Review of Wagga Wagga Floodplain Risk Management Study & Plan

Reference: R.A10413.001.05.WaggaWagga_FRMS_Review.docx
Date: July 2022
Final Report

Peer Review Finalisation

Figure 3-2 Histogram showing the distribution of difference in elevations between the 2009 LiDAR and FRMS&P 2018 values for residential properties

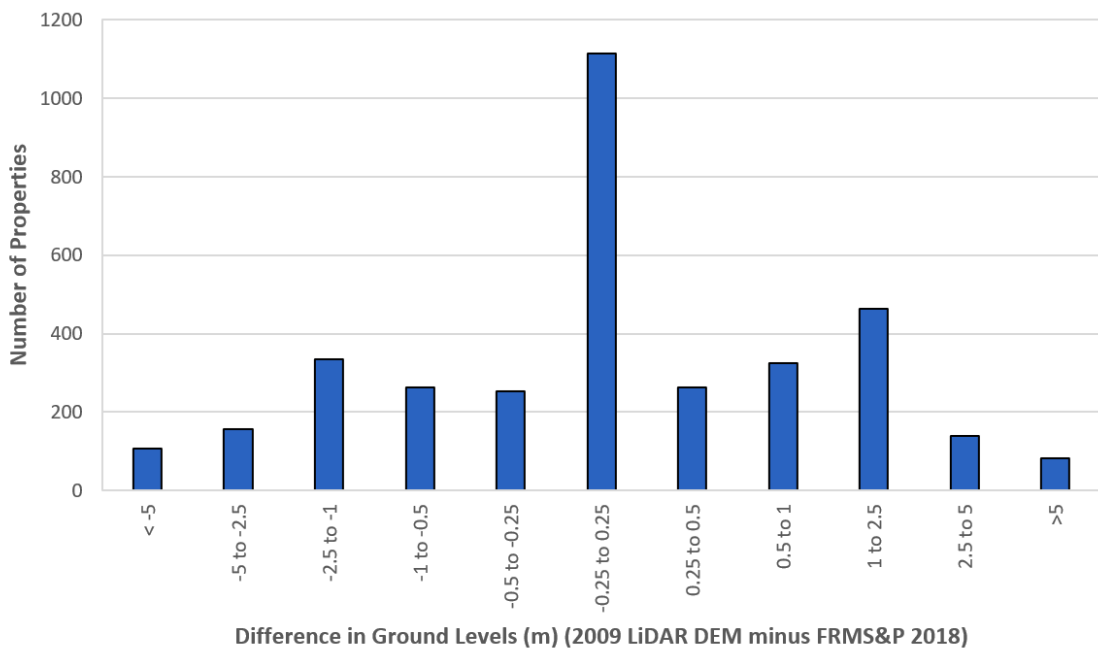
LiDAR DEM at the quoted X and Y coordinates is provided in Figure 3-2. This histogram quantifies the spread and magnitude of the variation and helps to understand the potential influence of this issue. For comparison, a similar histogram is also provided in Figure 3-3 for the non-residential properties. Note that the difference refers to the 2009 LiDAR elevation minus the elevation within the damage calculation spreadsheet.

The greater impacts on damage calculations at a property level would occur as a result of the property being newly impacted above ground and/or above floor, or alternatively no longer impacted above ground and/or above floor. However, the overall impact of this issue across the whole study area may result in a minor net change in total intangible damages or alternatively, may result in a significant net change in total tangible damages.

Figure 3-6 North Wagga Levee breach locations (shown as orange polygons)

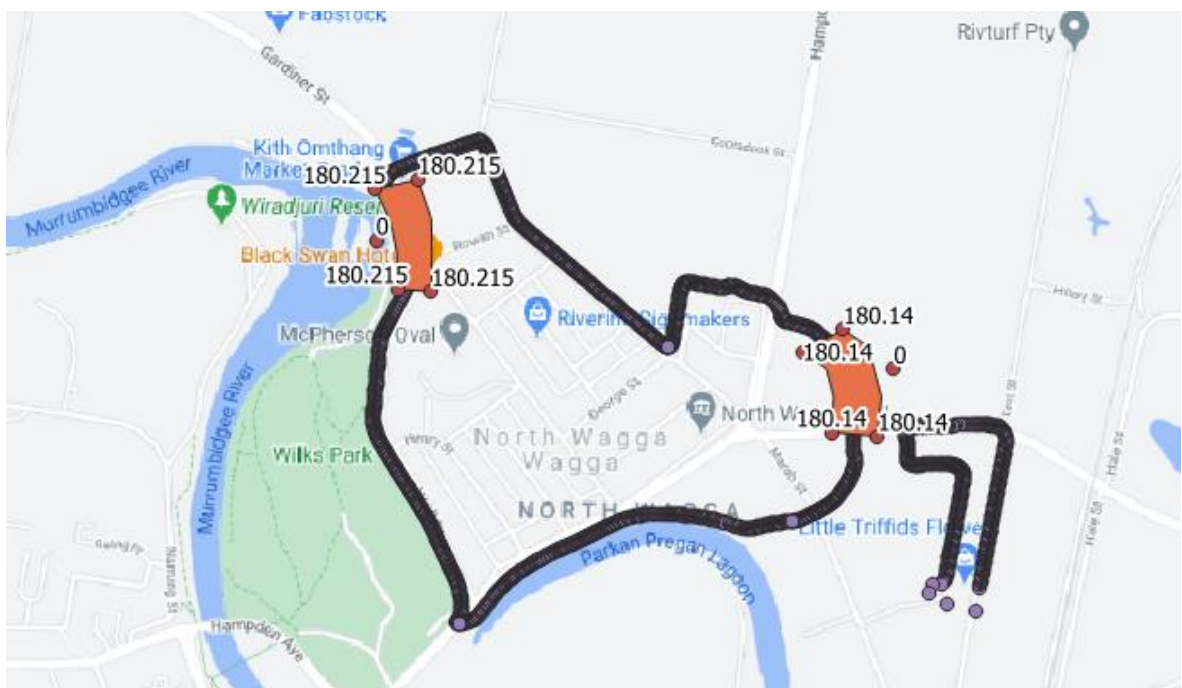
The breach of the existing North Wagga Levee is modelled by reducing a 100 m section on each side of the levee (upstream and downstream) to a level halfway between natural surface and the existing level of protection to allow controlled failure to occur. The breach is modelled in TUFLOW as a “variable Z shape”. Essentially, TUFLOW 2D model topography is varied over time to represent embankment failure when the water level reaches a specified height (in this case the design level of protection) at a specified trigger location (refer modelled breach locations in in Figure 3-6).

Under North Wagga Levee upgrade scenarios (i.e. Option L3(A-C) and L4(A-C)), the North Wagga Levee was reported within the FRMS&P 2018 to be modelled using the same approach as for the Wagga CBD Levee (described in Section 3.4.1) because the upgrades would include formal spillway designs. However, it is noted that the report does not define what portion of freeboard is removed from the spillways and the remaining freeboard that has been modelled for North Wagga Levee upgrades. Contrary to what was reported, the North Wagga Levee upgrade Option L4(B) was found to be hydraulically modelled based on a similar approach as the modelling of the existing scenario. That is, a breach was modelled by reducing a 100 m section on each side of the levee (upstream and downstream) to a level halfway between natural surface and the proposed level of protection to allow controlled failure to occur. A levee freeboard of between 0.3 and 0.6 m was found to be modelled (refer Section 4.3.2).

Damage values will be greater in areas protected by levees as a result of the FRMS&P 2018 approach. Therefore, this approach is considered to provide conservative damage estimates within levees, particularly within the Wagga CBD Levee because:

Figure 4-1 Modelled Levee Crest Elevation vs Design Flood Levels

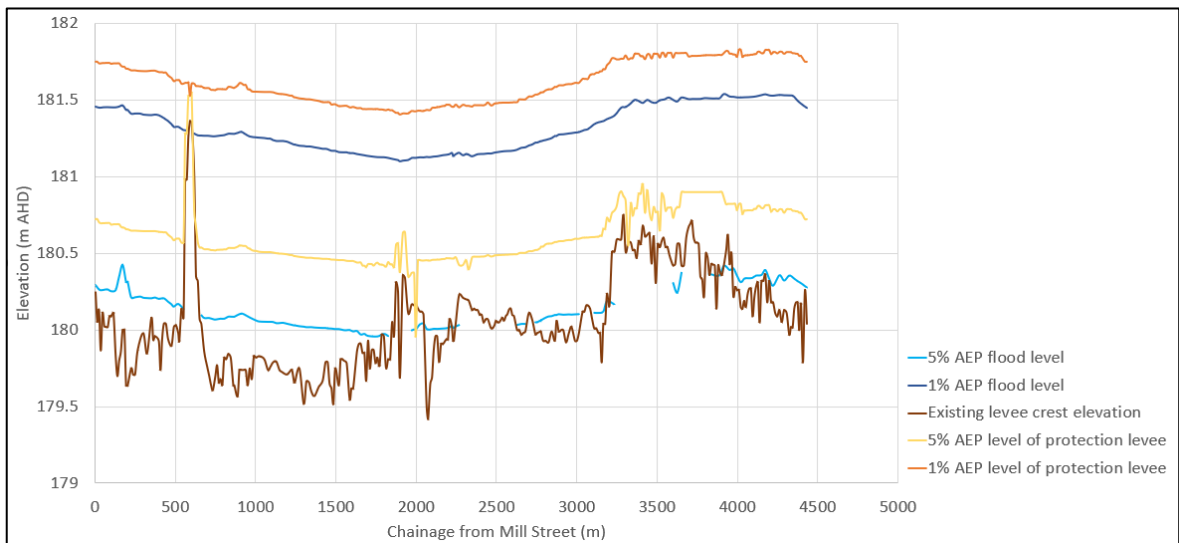
The FRMS&P 2018 report states that a freeboard of 0.75 m was recommended for the North Wagga Levee (Public Works, 2010), however Section 9.3.3.1 of the FRMS&P 2018 states that the proposed North Wagga Levee options include a freeboard of 0.7 m. Within the modelling, the crest of the levee is above the designed AEP flood level, with the freeboard generally varying between 0.3 m and 0.6 m based on a comparison of modelled levee elevations against modelled design flood levels. This is shown in Figure 4-1.

Therefore, neither the recommended nor reported levee freeboard is reflected in the modelling. Furthermore, the modelled freeboard for the no failure scenario was found to be the same as the modelled freeboard for the failure scenario for North Wagga Levee options (albeit without the spillway lowering). This finding is valid for modelling of all North Wagga Levee options but is in conflict with the approach reported in the FRMS&P 2018.
